<b>Property Information</b>	Taylor Ridge Subdivision Concept	
<b>Address</b>	Sullivan Gardens PKWY 3725	
<b>Tax Map, Group, Parcel</b>	Tax Map 090 Parcel 059.00	
<b>Civil District</b>	13 <sup>th</sup> Civil District	
<b>Overlay District</b>	N/A	
<b>Land Use Designation</b>	Single Family	
<b>Acres</b>	+/- 90	
<b>Owner/ Applicant Information</b>		
<b>Name:</b> T1V Properties Inc. <b>Address:</b> 1300 Jan Way <b>City:</b> Kingsport <b>State:</b> TN <b>Zip Code:</b> 37664		
<b>Planning Department Recommendation</b>		
<b>(Approve, Deny, or Defer)</b> <b>The Kingsport Planning Division recommends approval for the following reasons:</b> <ul style="list-style-type: none"> <li>• The proposed density and street cross-sections are compatible with County A-1 Zoning and the Kingsport Subdivision Regulations.</li> <li>• All city staff have reviewed the concept plan and send a positive recommendation for concept plan approval.</li> </ul>

The owner of Tax Map 090 Parcel 059.00, located in Kingsport's Urban Growth Boundary, is seeking concept plan approval from the Kingsport Regional Planning Commission. This is the same property that was brought before the Commission last year for a county rezoni

**Proposed Street Cross-Sections**

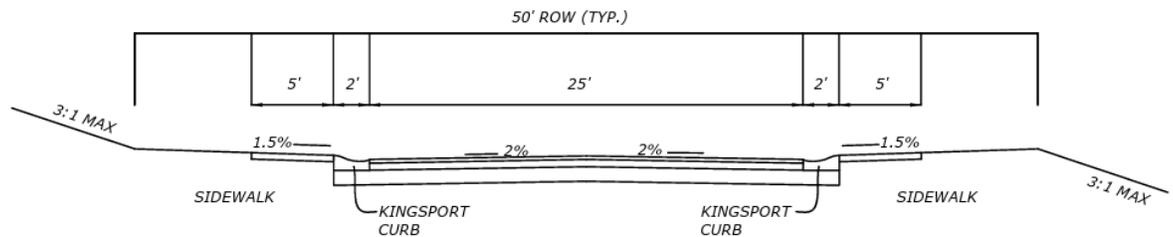
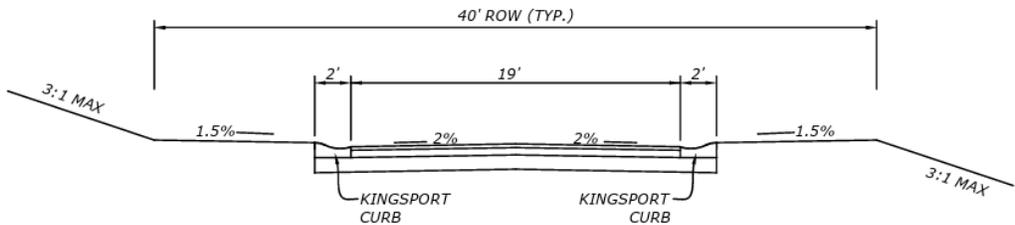
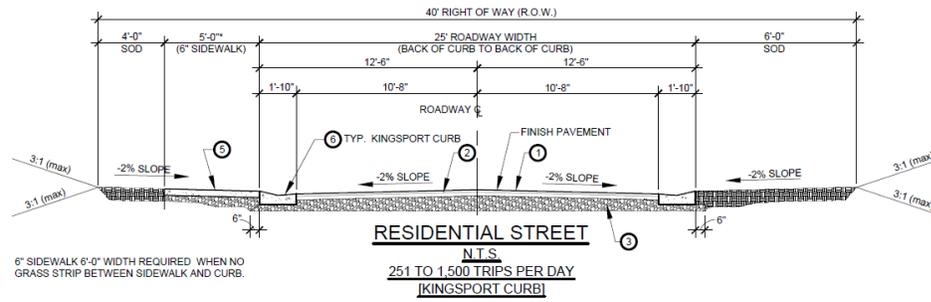
<b>Staff Field Notes and General Comments:</b> The Concept Plan submission is <i>optional</i> but allows the subdivider and city officials to save time and prevent costly revisions to the formal application for plat approval later on. The Concept Plan should show the entire tract and contain the following: <ul style="list-style-type: none"> <li>• The location of the proposed subdivision in relation to the neighborhood in which it is located.</li> <li>• A simple plan showing general layout of lots and streets, major drainage ways and other features relevant to existing conditions on the site and adjoining street system.</li> <li>• General subdivision data including land characteristics, proposed community facilities and utilities, typical building sites, street widths, street cross sections, total proposed disturbance, and contours where necessary.</li> </ul> <p>Beginning at Sullivan Gardens Parkway and ending at Lot 38 the roadway would need to be a residential street at a minimum. The proposal calls for a local street cross section, which will exceed minimum standards. Every additional roadway past lot 38 could qualify as a residential lane if desired based upon the number of trips generated by the remaining lots.</p>
